ADDENDUM

PROJECT: South Dakota Army National Guard
Renovate Entrance Doors Statewide – Area B
Statewide, South Dakota

AD-1

DATE ISSUED: Monday, September 25, 2017

SHEET NUMBER
A-601

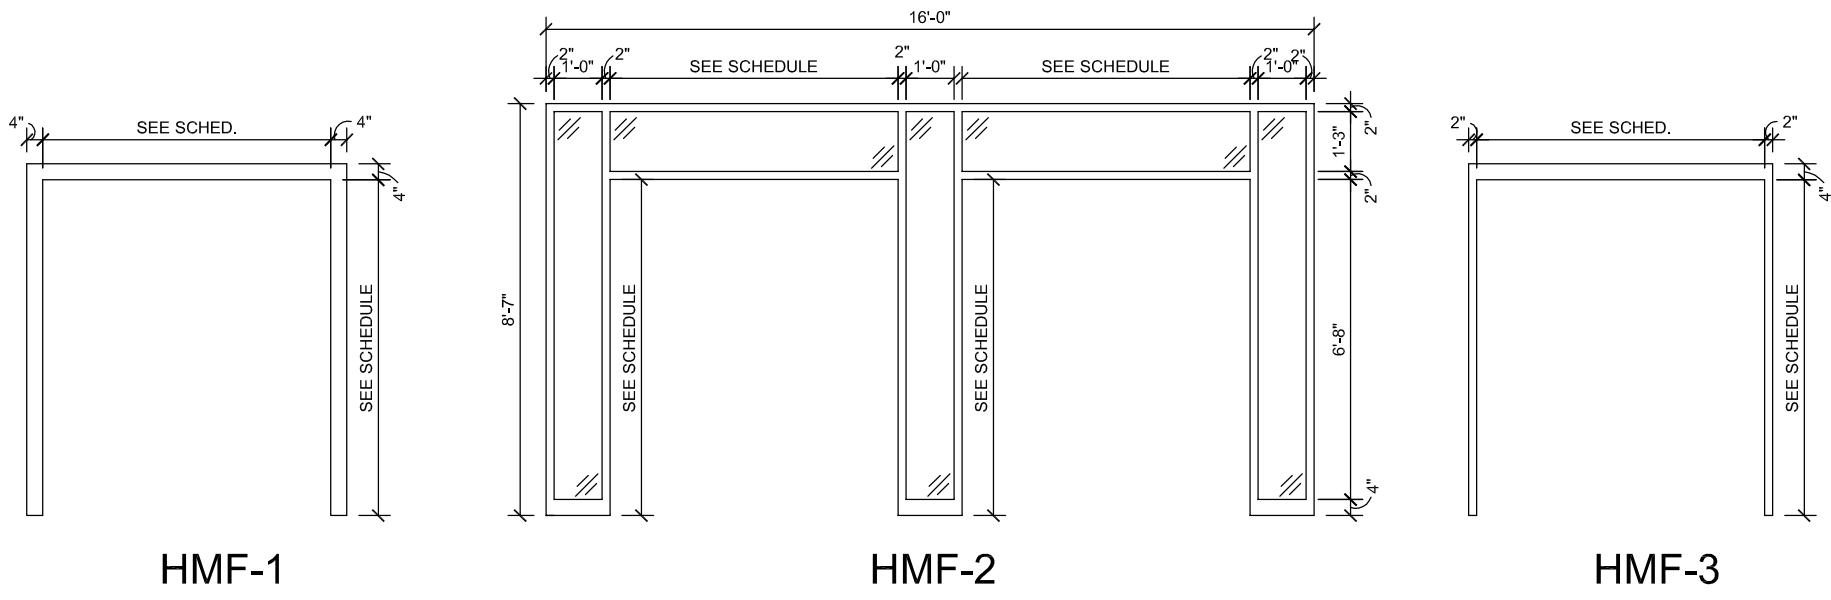
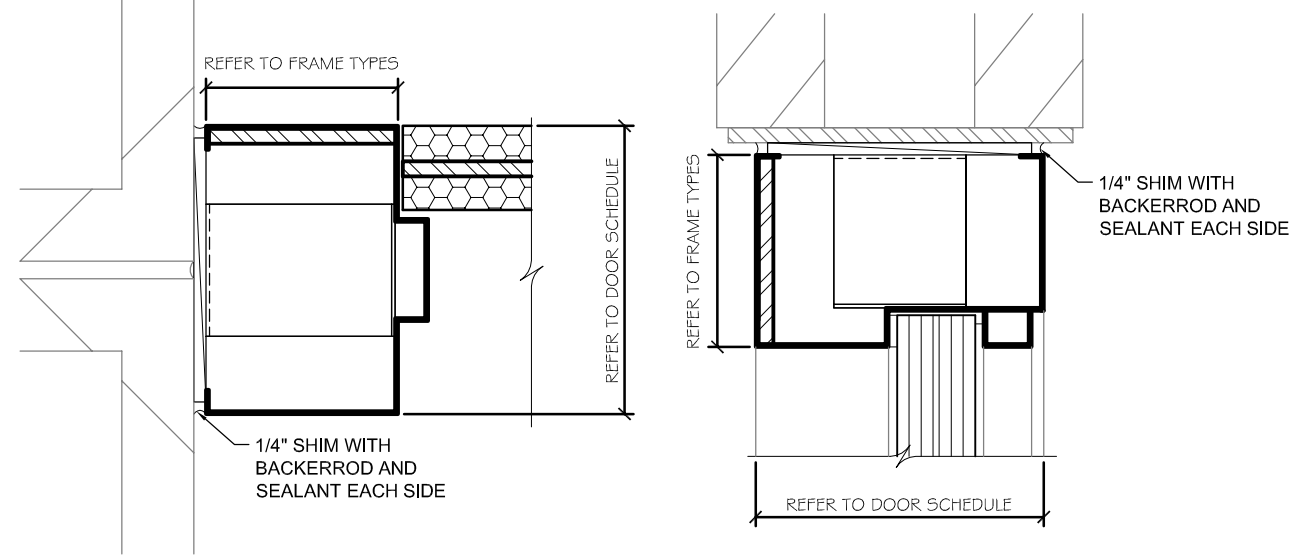
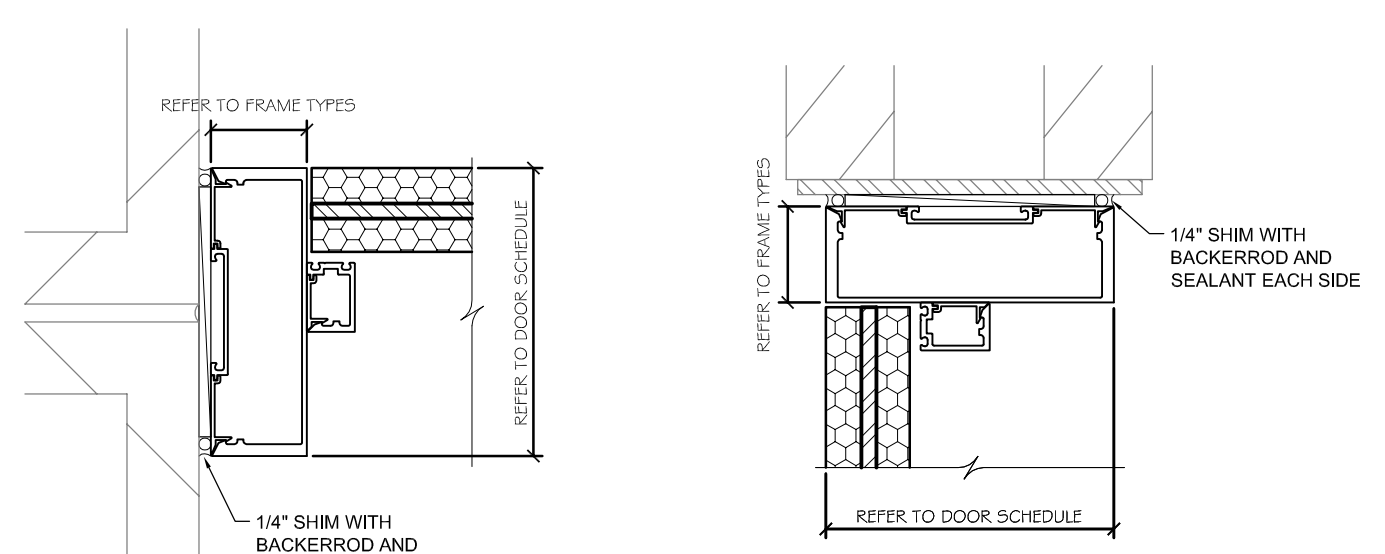
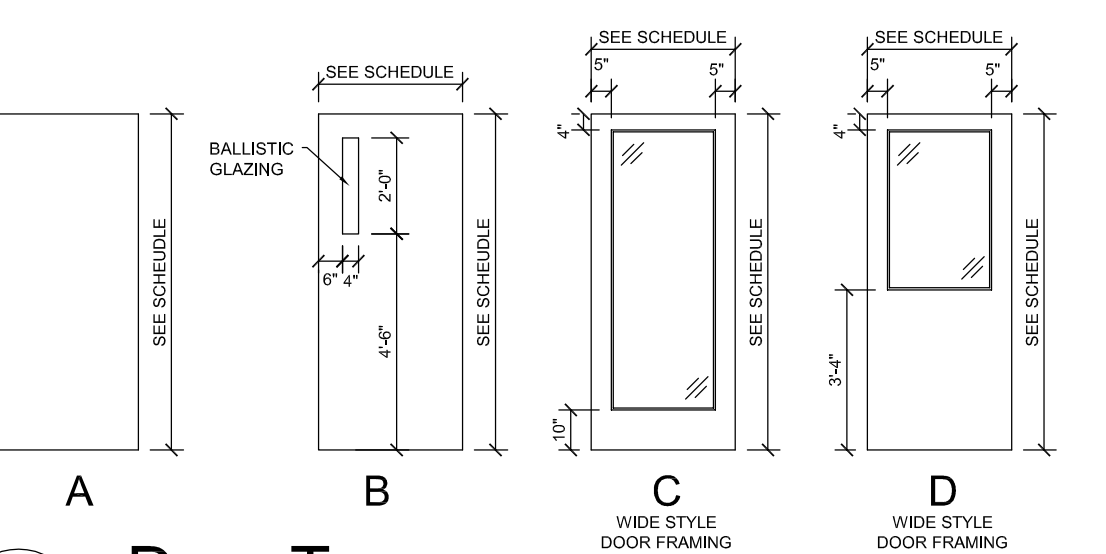
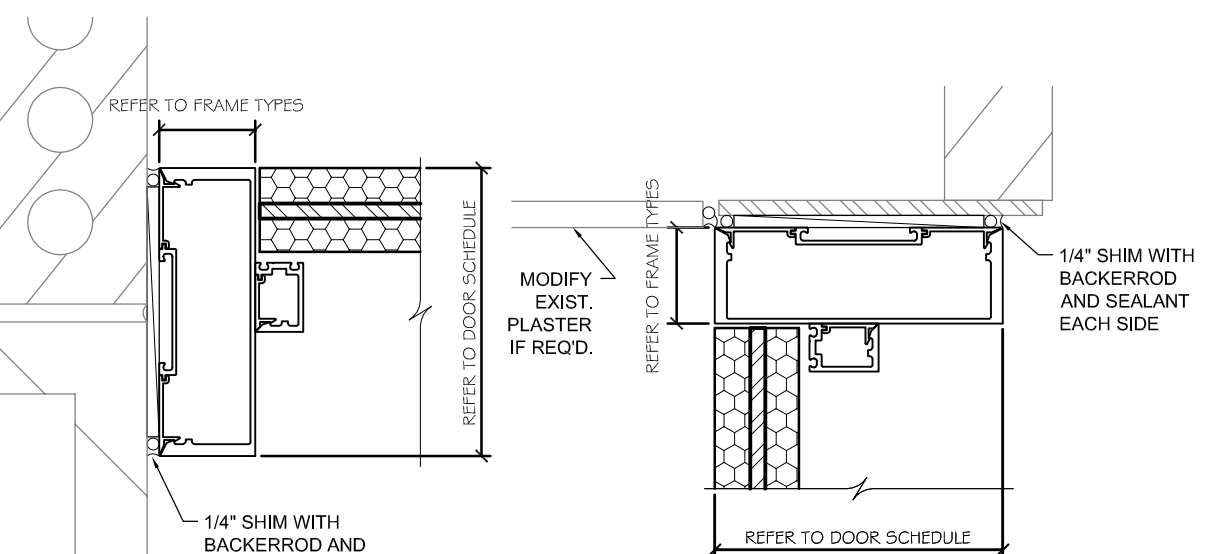
A Revised Sheet A-601 is attached

As a matter of clarification, the existing finishes for the aluminum doors and frames are as follows:

- Aberdeen Armory – Dark bronze
- Brookings Storefront – White
- Huron Armory (West Entrance)– Clear
- Huron Armory (East Entrance)– Dark bronze
- Watertown Readiness Center – Custom color, field verify
